PLANNING APPLICATION P/14/029

NEWFORT HOUSE
PORTHLOO, ST MARYS

PROPOSED
ELEVATIONS

DRAWING NO. 014-7A
DATE - JULY 2014
SCALE - 1:100 & A3

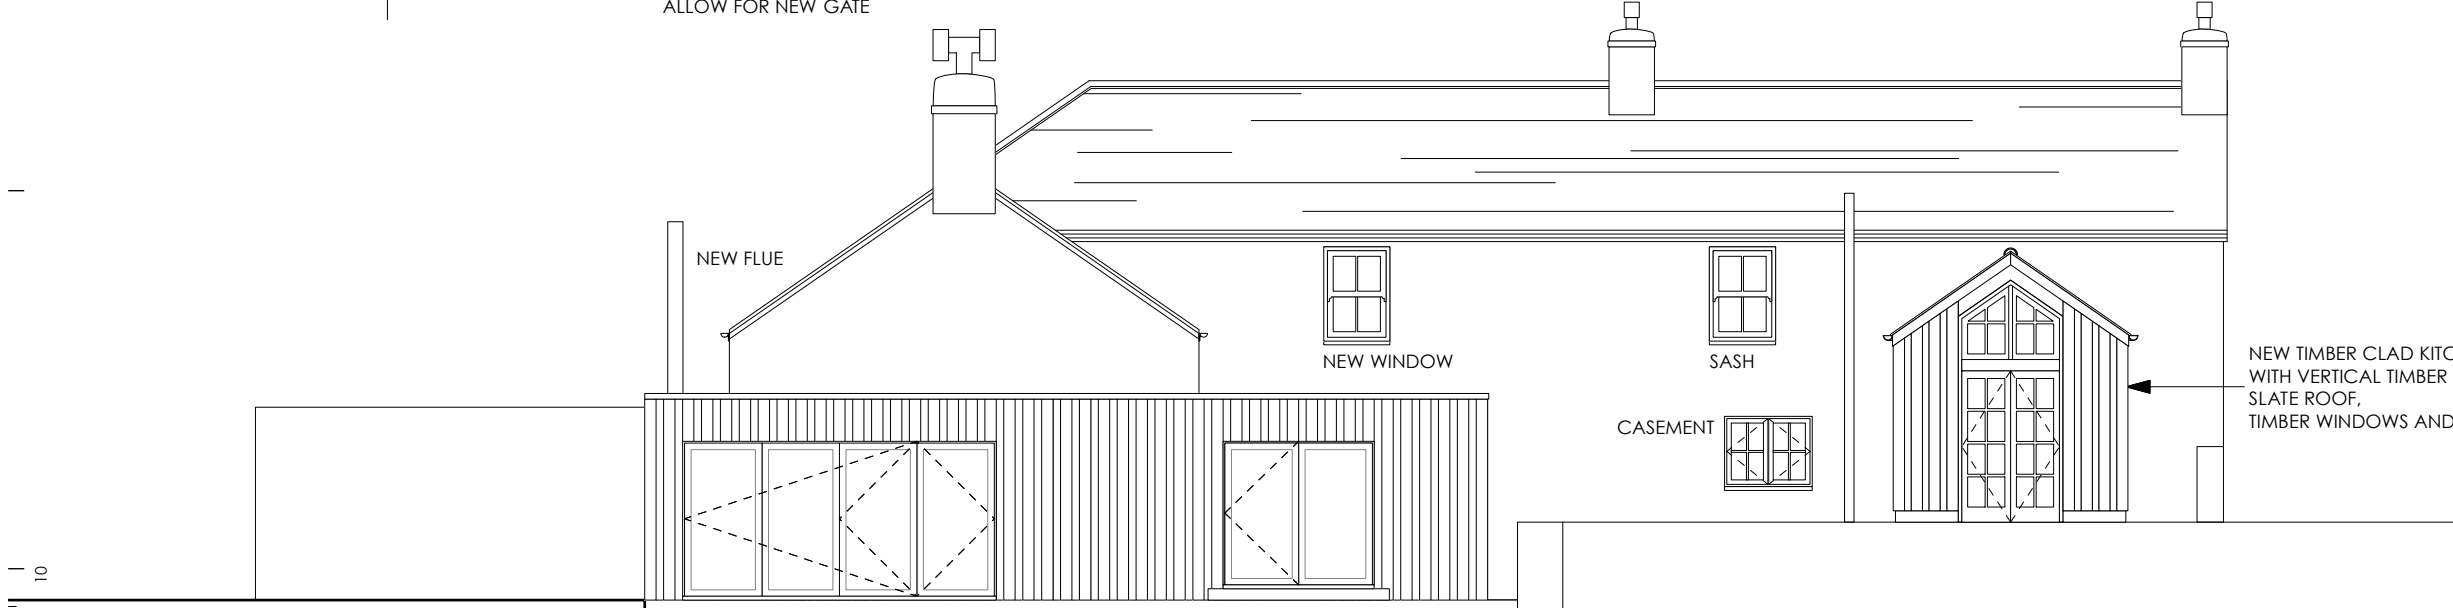
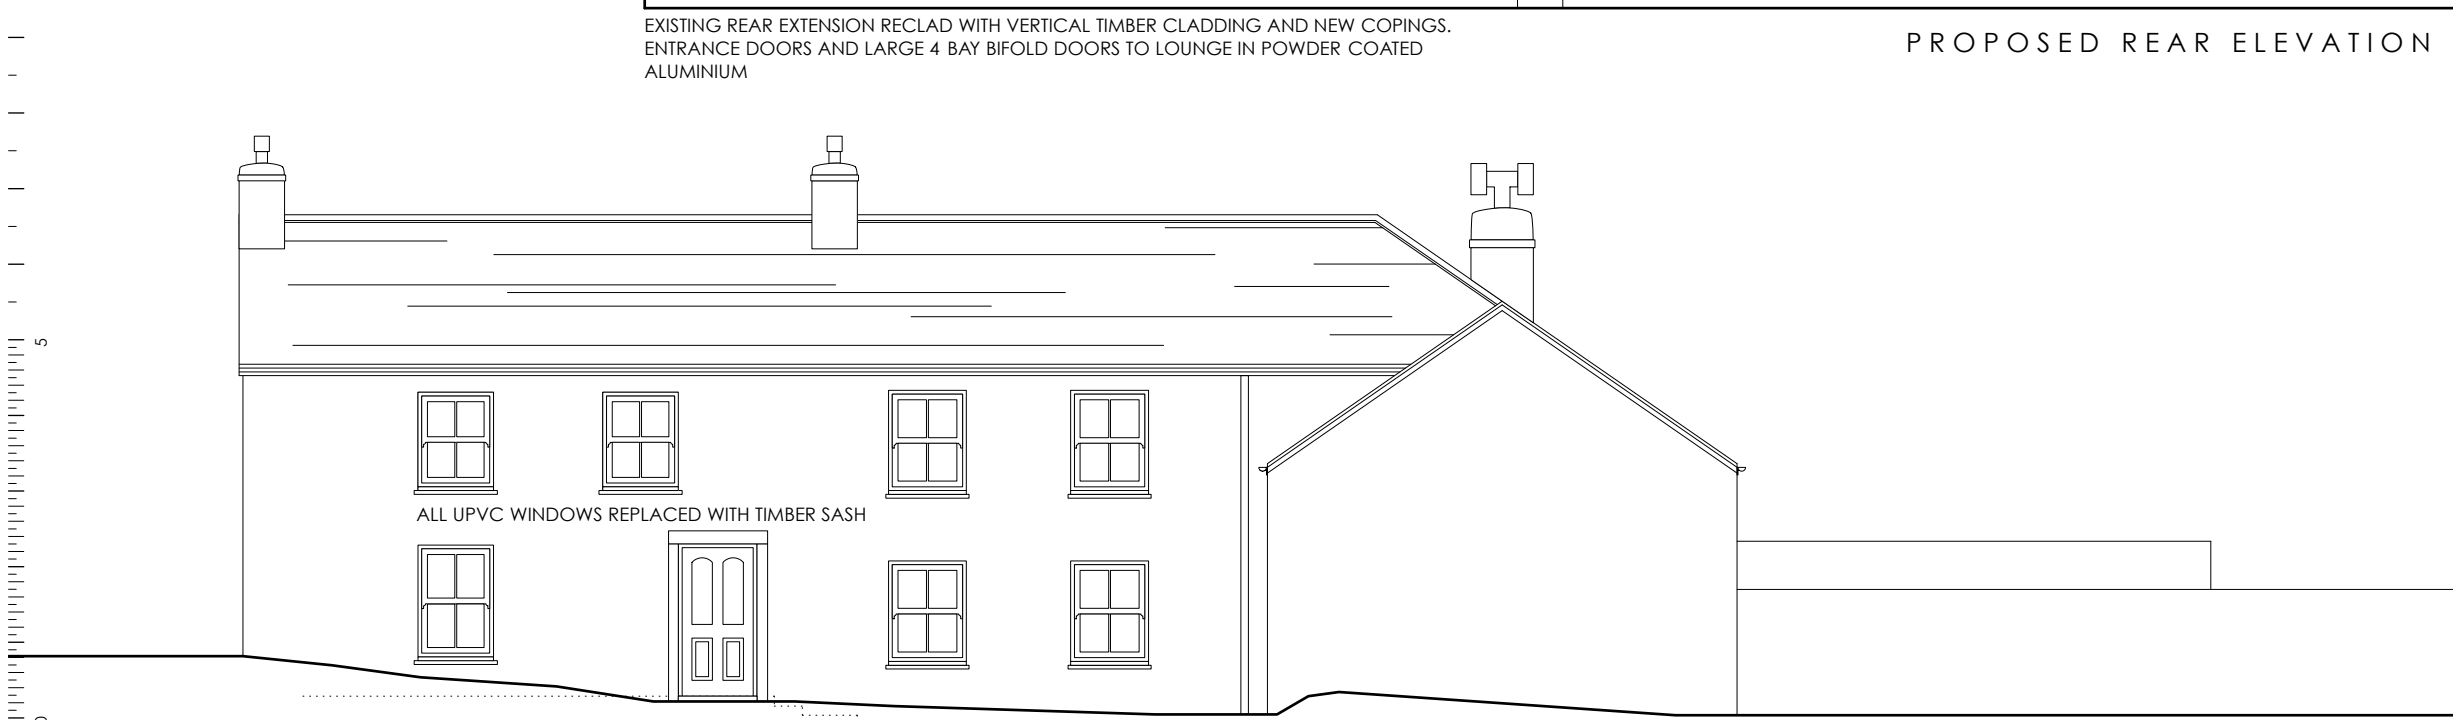
REVISION A - 13TH JULY 2014
SHIPLAP CLADDING REVISED TO
VERTICAL TIMBER CLADDING
